LAKEFRONT BLOCKS

BLOCK
37

EARLY DESIGN GUIDANCE #2
WEST DESIGN REVIEW BOARD
MEETING ON NOVEMBER 19, 2014

RUNBERG ARCHITECTURE GROUP
VULCAN REAL ESTATE

AERIAL PERSPECTIVE OF MASSING PRESENTED AT EDG #1 ON 9/17/14

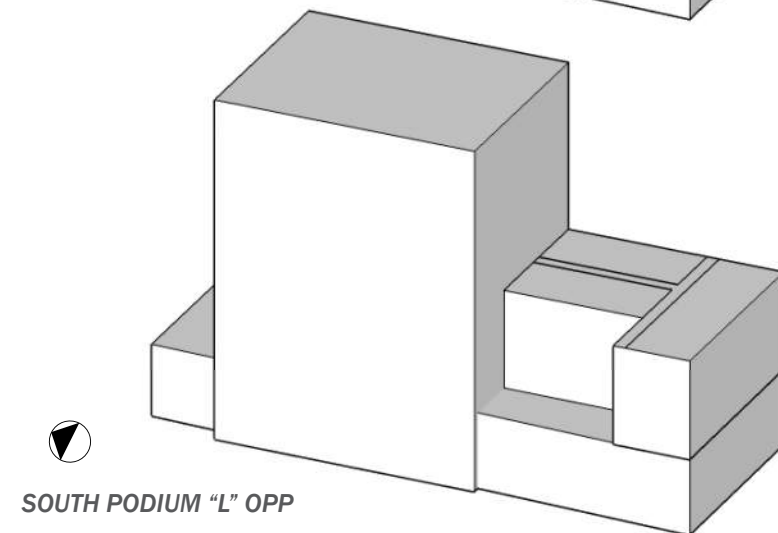
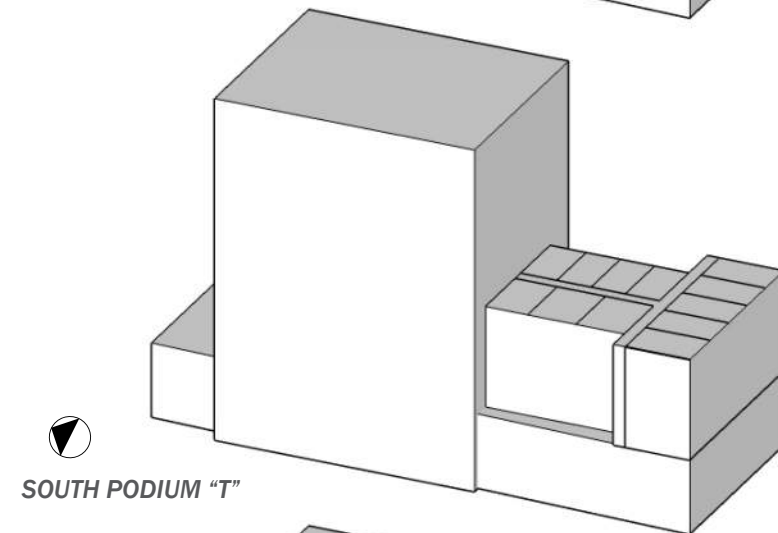
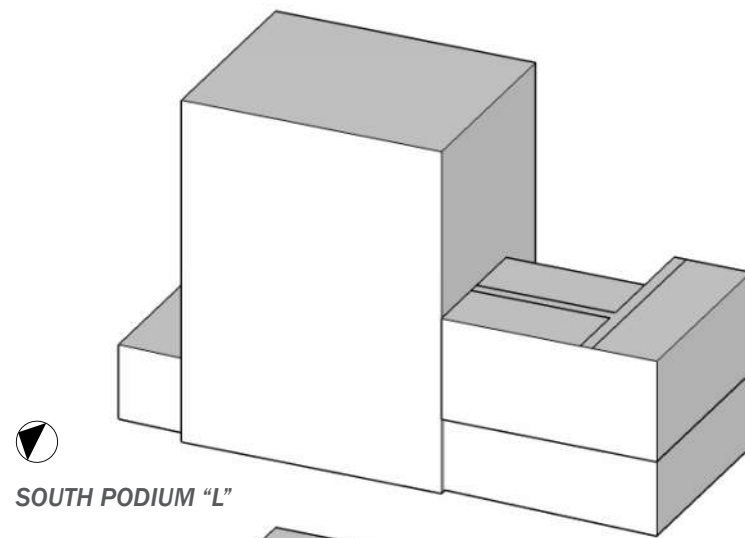
The integration of sustainable strategies for site and building are encouraged

More facade modulation at all four sides of the tower is recommended to reinforce vertical proportions

The board requested a reduction in at-grade parking, reserving spaces only for car share and handicap vehicles.

The site has been recognized as a bicycle and transit nexus. Increased bicycle storage with direct access to street is supported.

Redesign southeast corner of building to provide better presence at the corner of Mercer and the alley

For the south podium, a broader massing along Mercer was encouraged

Townhouse massing and design expression should be more cohesive with the rest of the podium design

SCHEME A - CODE COMPLIANT

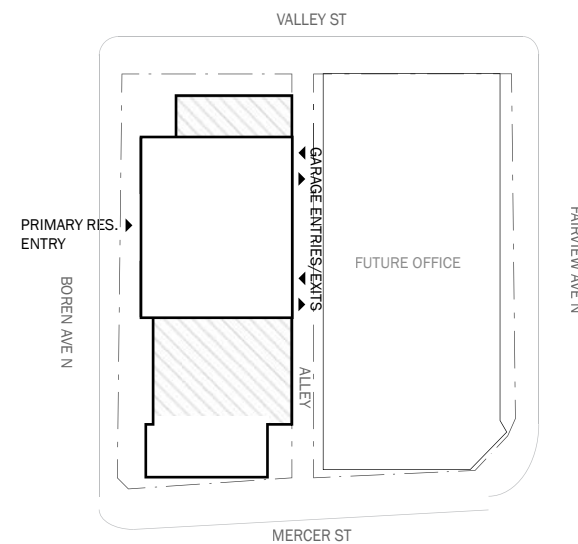
- There were no comments on the code compliant scheme.

SCHEME B

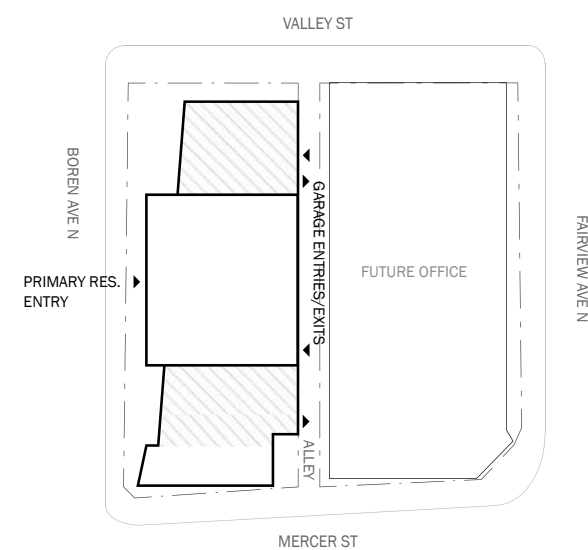
- One board member liked the continuous angled expression at the ground plane, arguing that it helped clarify the massing.
- The location of the tower does not provide adequate hierarchy between the north and south podiums.

SCHEME C

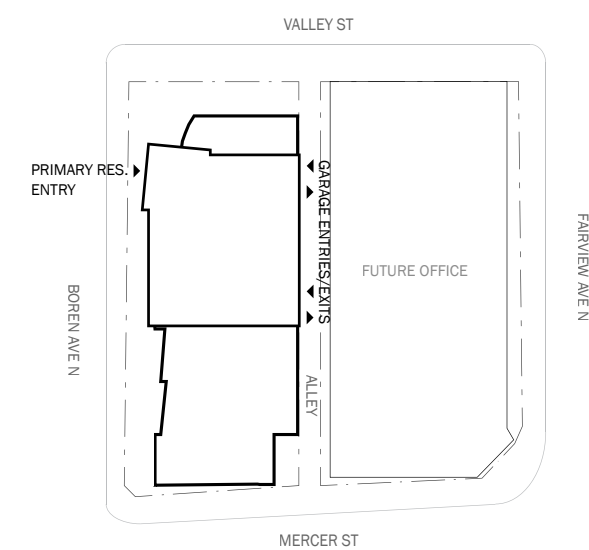
- Tower location is good.
- Massing of south 85' podium feels unresolved, with too many parts.
- Ground floor uses are not clearly expressed with the architecture.
- The modulation shown in the tower was received favorably and more was requested.

GROUND FLOOR USE BEFORE

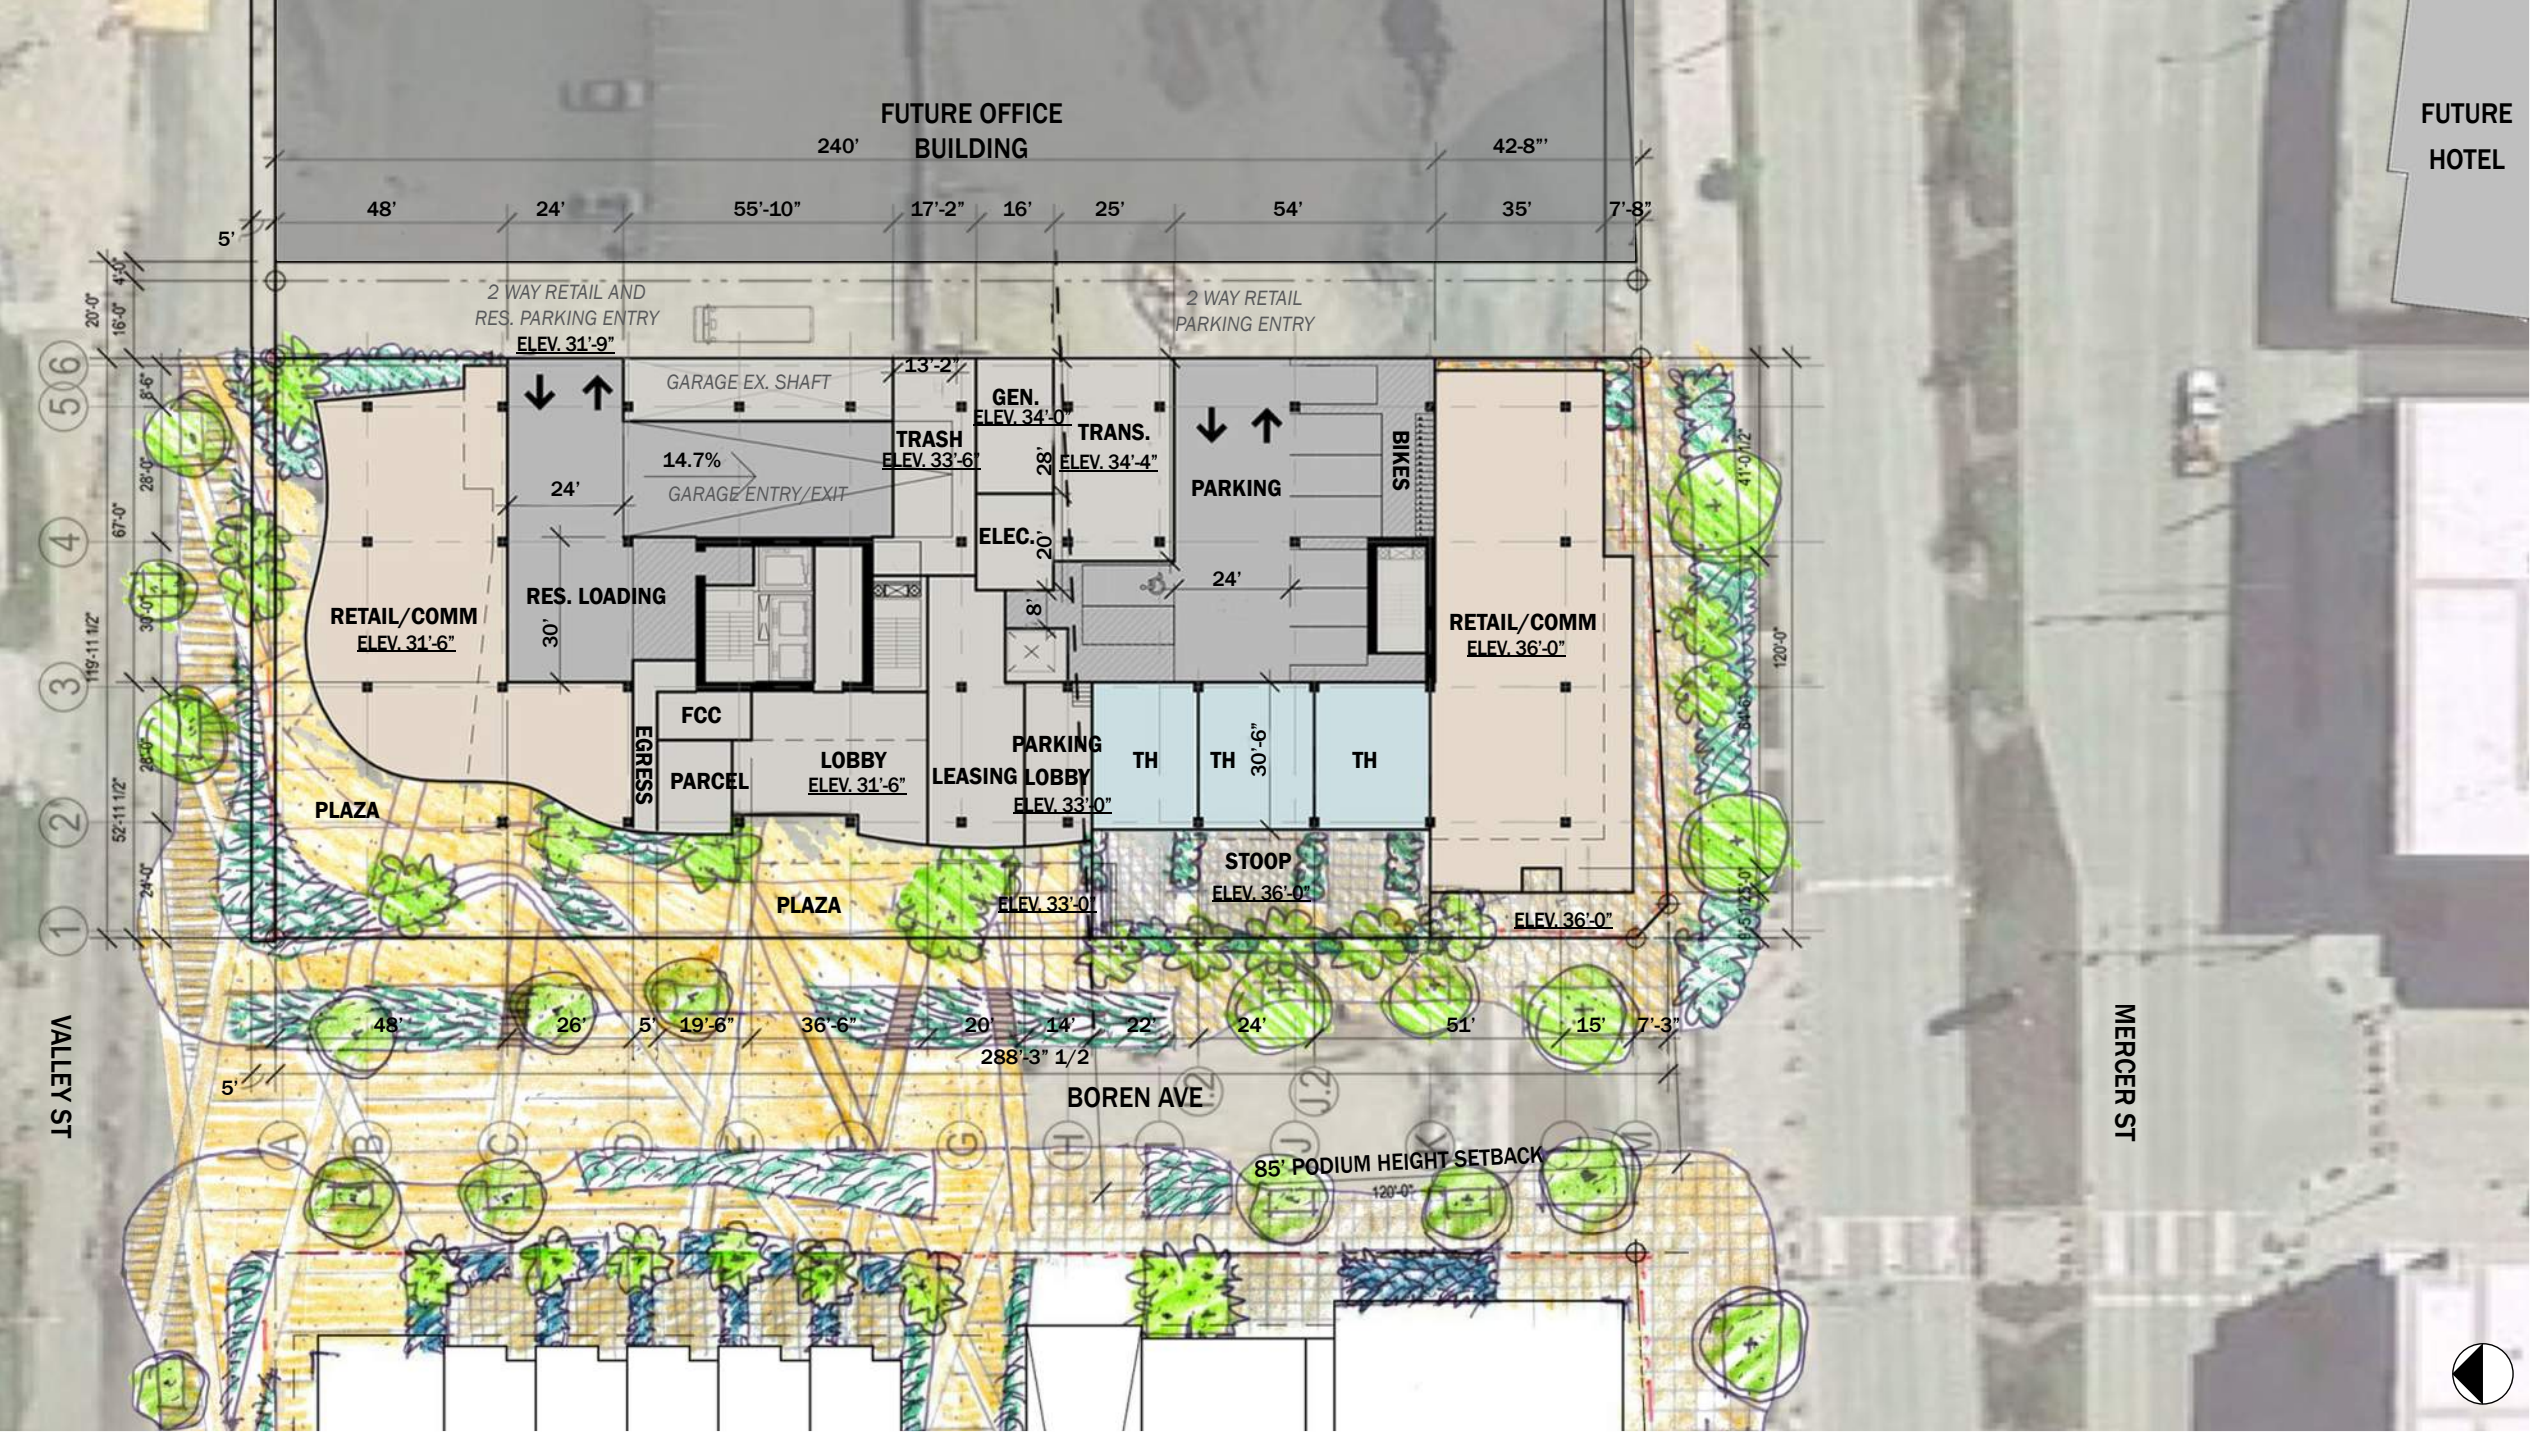
- The integration of sustainable strategies for site and building are encouraged
- Retail off the north plaza should extend further south
- The northwest corner generous plaza and raised platform (2-3 ft.) is supported by the board

- Basic tower placement is endorsed. Better resolve the expression of extra-thin columns, curving base, and "extra townhouses" at the southwest corner base

- The north storefront shape does not have to be curved. Other forms would work as well.
- Revise programming to provide better visual terminus of the through-block connection on Block 31.

- Some of the tower's verticality could extend to grade along Boren
- The board requested a reduction in at grade parking, reserving spaces only for car share and handicap vehicles.

- Townhouse massing and design expression should be more cohesive with the rest of the podium design.
- The site has been recognized as a bicycle and transit nexus. Increased bicycle storage with direct access to street is supported

- Redesign southeast corner of building to provide better presence at the corner of Mercer and the alley.
- For the south podium, a broader massing along Mercer was encouraged.

- Retail wrap corner and has more of a presence on the plaza.
- Leasing moved south of the lobby
- Through block terminus to public parking access and Leasing office. Fewer townhouses and shifted south
- Retail and public bicycle parking accessed at ground level off alley
- Retail at Mercer extended to be adjacent to alley. Strong street frontage on Mercer and no more plaza abutting the alley

GROUND LEVEL EDG # 1

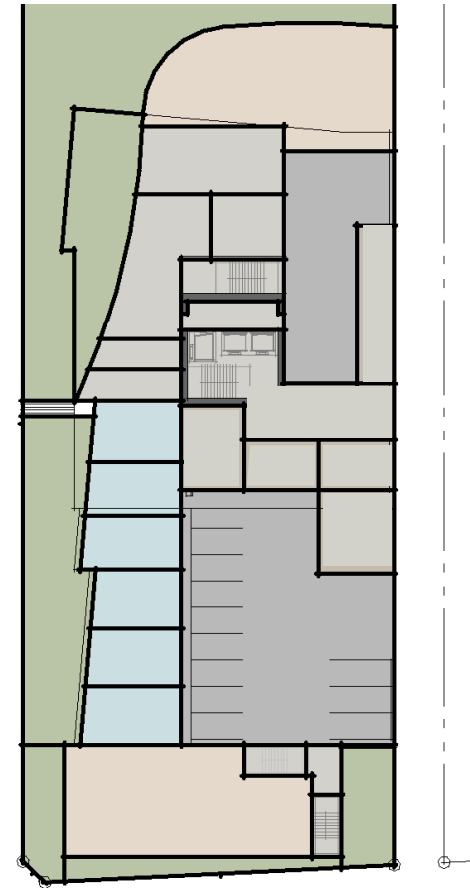
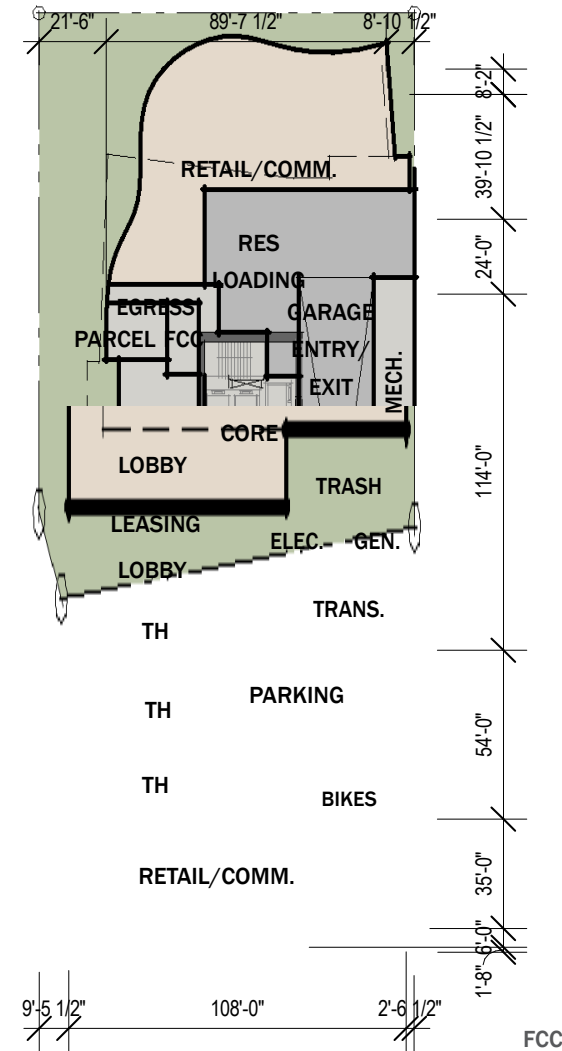
At **EDG #1**, there were **12** ground level parking spaces

Parking shown at ground level is for public and retail uses, including barrier free stalls. Currently there are **8** parking spaces.

SITE VIEW FROM NW SHOWING ROOFTOP CANOPY

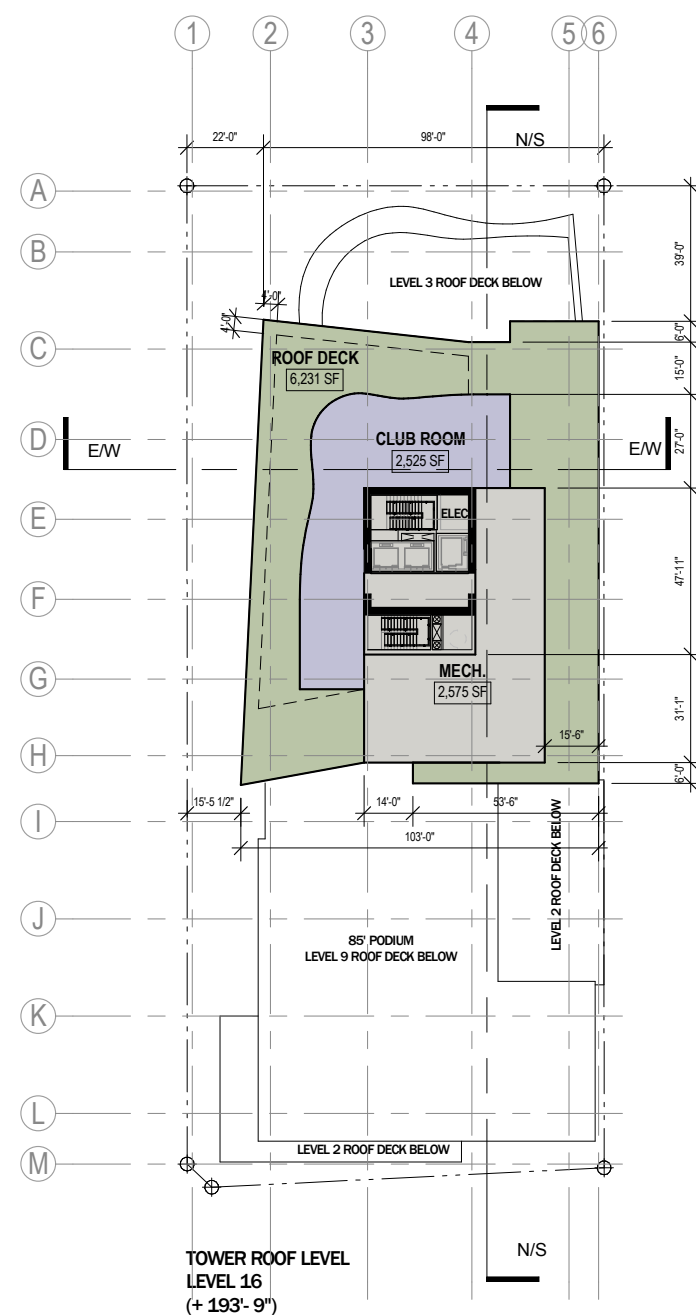
A departure is requested to lessen the distance required to edge of roof for rooftop features, including the rooftop canopy along the north and west facades, and the mechanical screen on the south facade. The requirement for maximum of 65% coverage will be met.

Rooftop canopies act as a lighthouse. This design concept is part of the design language for this site and the neighboring sites. From the north they will act as a beacon. They have minimum impact from the street level, as seen in the adjacent perspectives. The tower has been held back 39'-0" from the north property line, which is 14'-0" more than the code minimum setback of 25'-0", therefore, the roof canopy will not create additional shading conflicts for properties north of the site.
